RAC PUBLIC AFFAIRS

WRITTEN REPRESENTATION

HIGHWAY ENGLAND'S RESPONSE

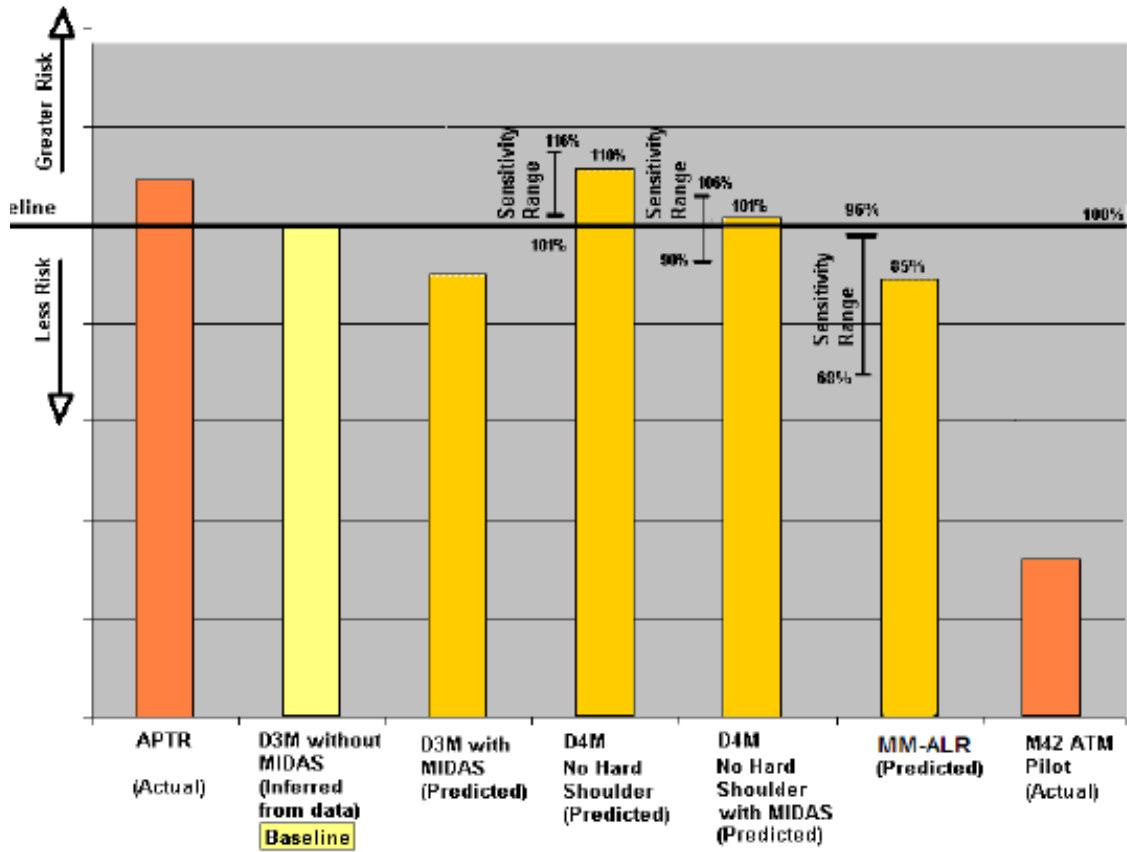
(ii) *The second illustrations shows a breakdown of the risk components for an All Lanes running configuration and a conventional motorway with 3 running lanes and a permanent hard shoulder. This demonstrates that motorway users are at greater risk when a vehicle breaks down or stops in a running lane for any other reason compared to a conventional motorway.*

2.5.5 The second illustration in the representation above provides a breakdown of the risk components for an All Lanes running configuration and a conventional motorway with 3 running lanes and a permanent hard shoulder. The hazard log for the Scheme is based upon the generic hazard log and is summarised below.

2.5.6 As per the generic hazard log the Scheme's hazard log contains the 17 highest scoring existing motorway hazards (i.e. those with a risk score of E08/S08 and above). Thirteen of these are expected to reduce in risk with the implementation of ALR, two are expected to remain the same and two are expected to increase in risk. The hazards referenced in the question are the two hazards expected to increase in risk with the implementation of ALR:

- H135 Vehicle stops in running lane - Off peak, which is estimated to increase in risk from an E07.50 to an E08.00, and
- H149 Vehicle drifts off carriageway (i.e. leaving the carriageway as a result of the road environment), which is estimated to increase in risk from an E08.00 to an E08.10.

2.5.8 The second illustration above shows that there is an increase in risk of the hazard relating to vehicles stopping in a live lane (off peak). To mitigate against this,

Comparison of risk for different carriageway configurations

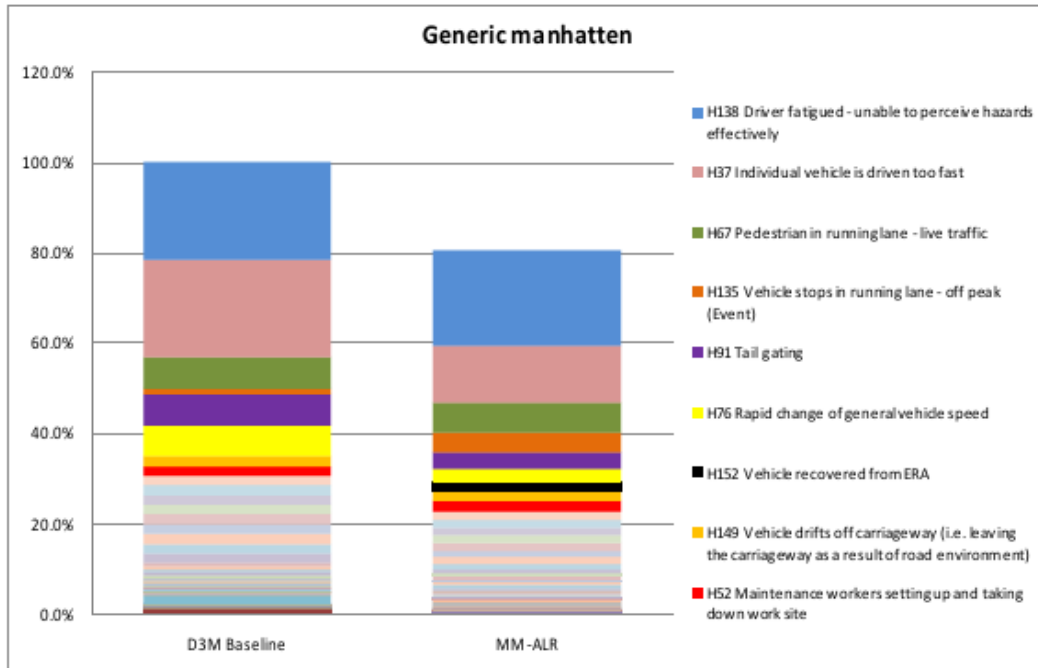
(i) *The first illustration below shows the relative risk associated with various motorway configurations.*

2.5.2 The first illustration in the representation above shows the relative risk associated with various motorway configurations. It shows that the ALR concept is expected to provide a similar level of safety benefit to a dual three lane motorway (D3M) with MIDAS, and both configurations provide a safety benefit when compared to the baseline. It also shows that the M42 Pilot provides the greatest reduction in risk compared with the other motorway configurations.

2.5.3 The first illustration above has been updated based on further analysis by Highways England in Figure 1 below to show that a generic ALR scheme is expected to provide a safety benefit of 18% when compared to a generic baseline (a D3M without MIDAS). It shows that the Scheme is expected to provide a similar safety benefit of 18% to that experienced with a generic ALR scheme compared to a generic baseline. It also shows that the Scheme is expected to provide an 8% reduction in risk when compared to the existing M4 motorway (D3M with MIDAS).
